SPARC Enterprise M3000/M4000/M5000/ M8000/M9000 Servers

Product Notes for XCP Version 1118

Manual Code: C120-0004-01EN
October 2014, Revision A

M9000 Servers Installation Area

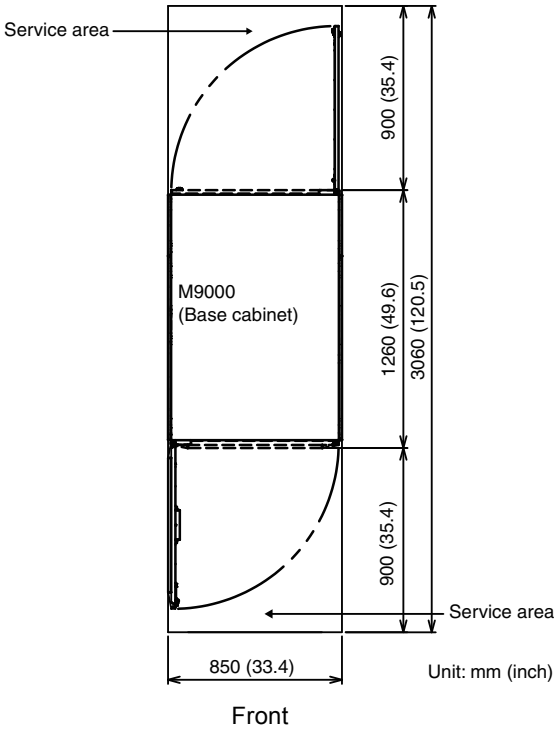
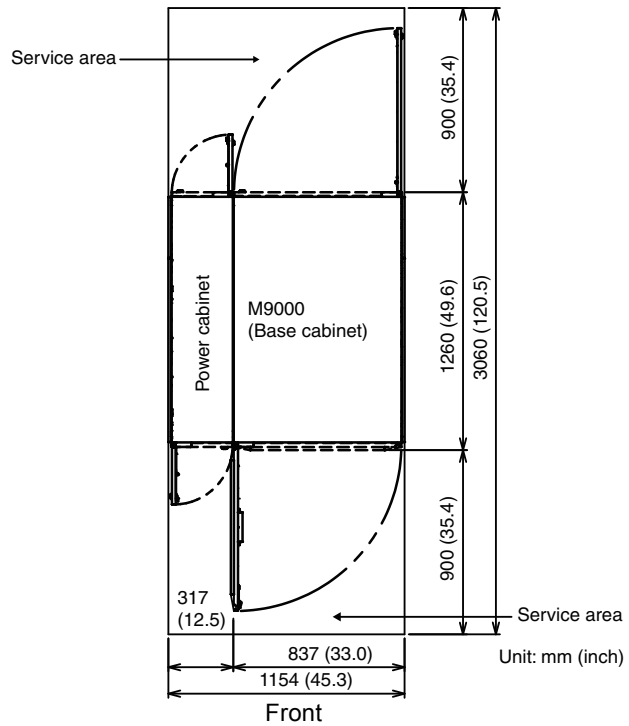
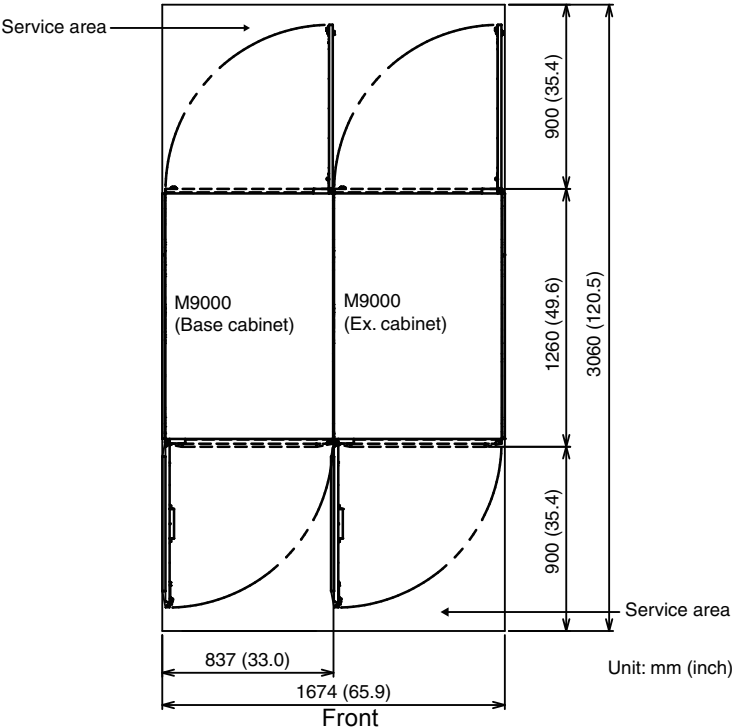
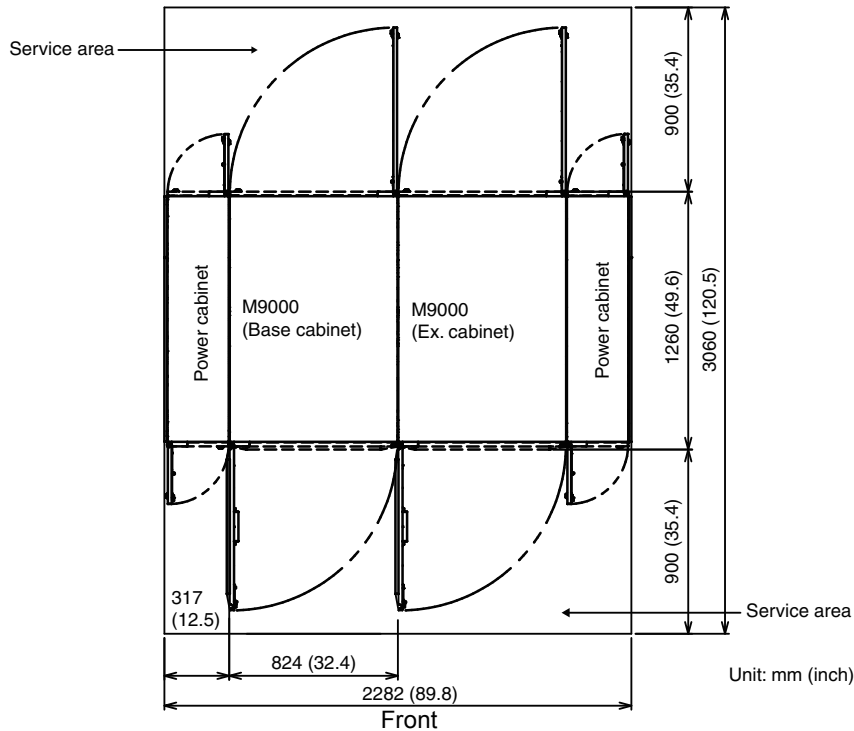
SPARC Enterprise M8000/M9000 Servers Site Planning Guide	1-18	A part of values in inches on FIGURE 1-13 to FIGURE 1-16 will be corrected. For detail, see “M9000 Servers Installation Area” on page 119 .
	1-35	For the order number of Vibration-proof bracket and Vibration-proof feet, see “Miscellaneous Information” on page 123 .
SPARC Enterprise M8000/M9000 Servers Service Manual	7-8	The mounting location of I/O Unit (IOU) indicated on FIGURE 7-4 will be corrected. For detail, see “I/O Unit (IOU) Mounting Locations” on page 122 ."

The following information supersedes the information in the *SPARC Enterprise M8000/M9000 Servers Site Planning Guide*
